ADDENDUM NO. 01

November 14, 2023

RE: Project No. 49-23-CMO

City Hall Annex Building VRF HVAC Installation

REVISION /1\ADDENDUM 1 | 11/10/23

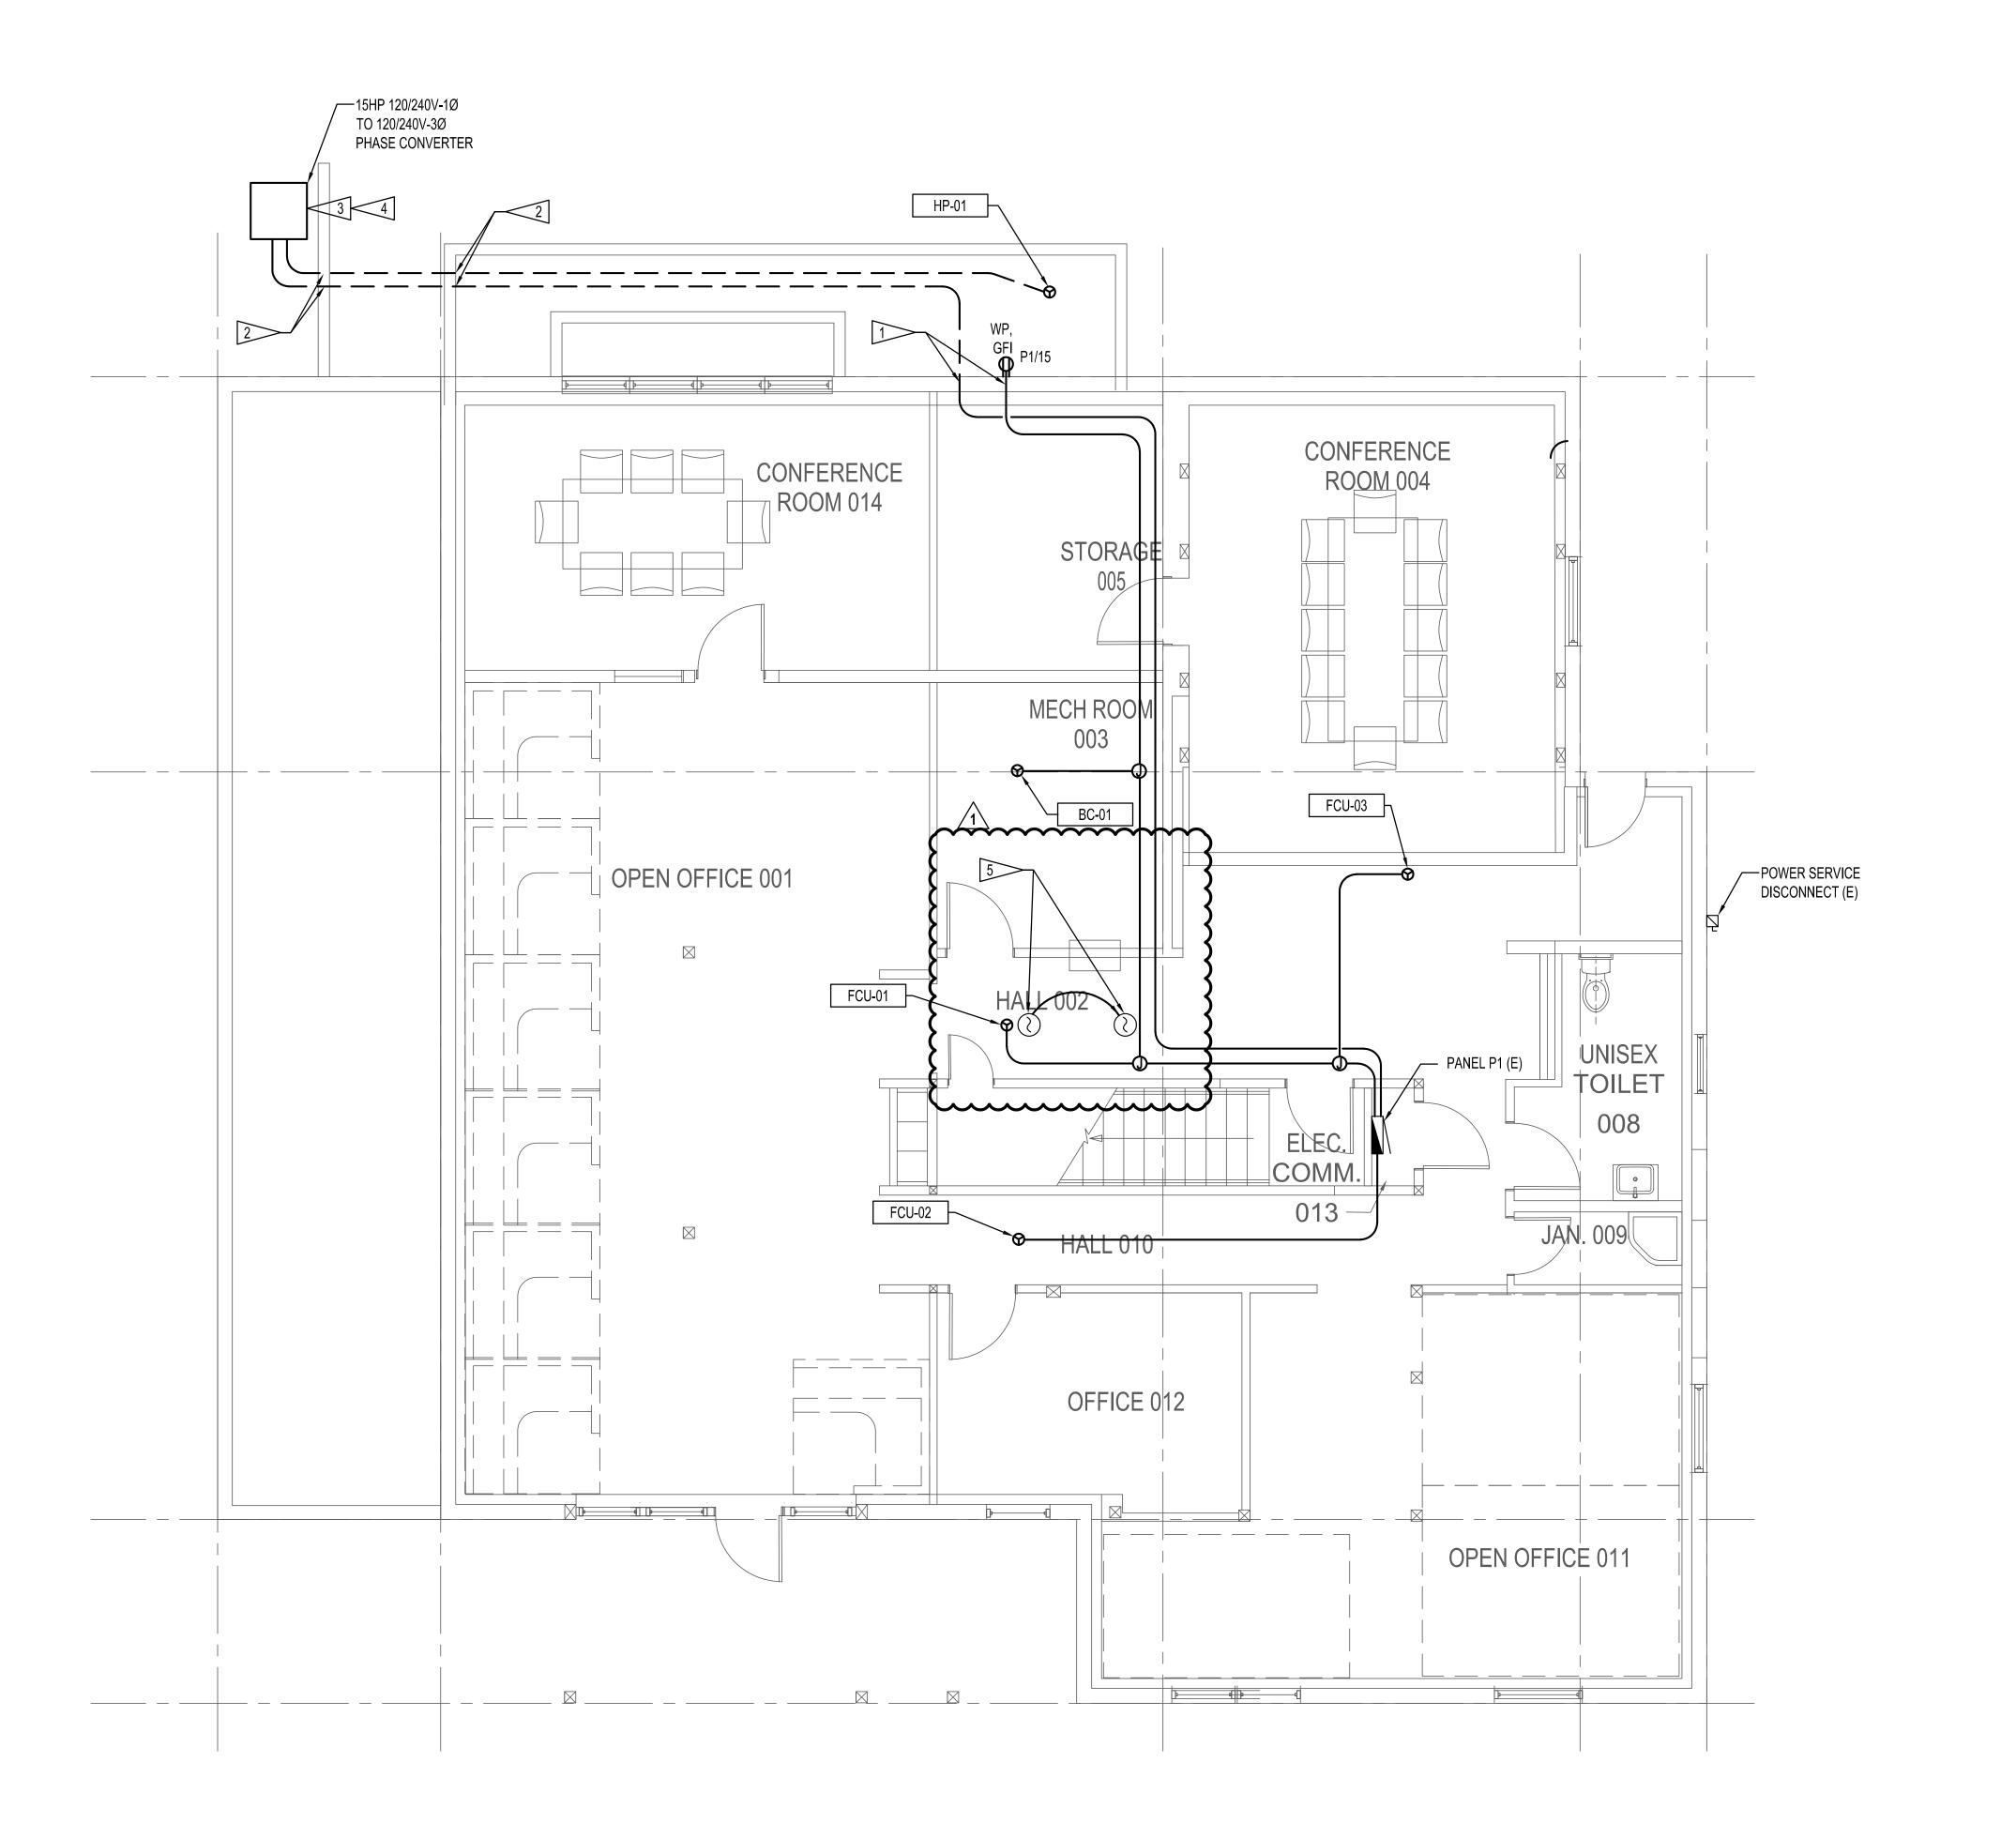
- 1. Replace drawing M-0.1 with attached revised drawing dated 11/10/2023.
- 2. Replace drawing E3.1 with attached revised drawing dated 11/10/2023.
- 3. On Sheet E3.2, revise General Note 1 to read "SURFACE MOUNTED CIRCUITS SHALL UTILIZE SURFACE METAL RACEWAY. FIELD VERIFY LOCATION OF BEAMS. PROVIDE ALL REQUIRED FITTINGS TO ROUTE AROUND BEAMS. CONDUITS CAN BE ROUTED IN ATTIC SPACE AND UTILIZE EMT."
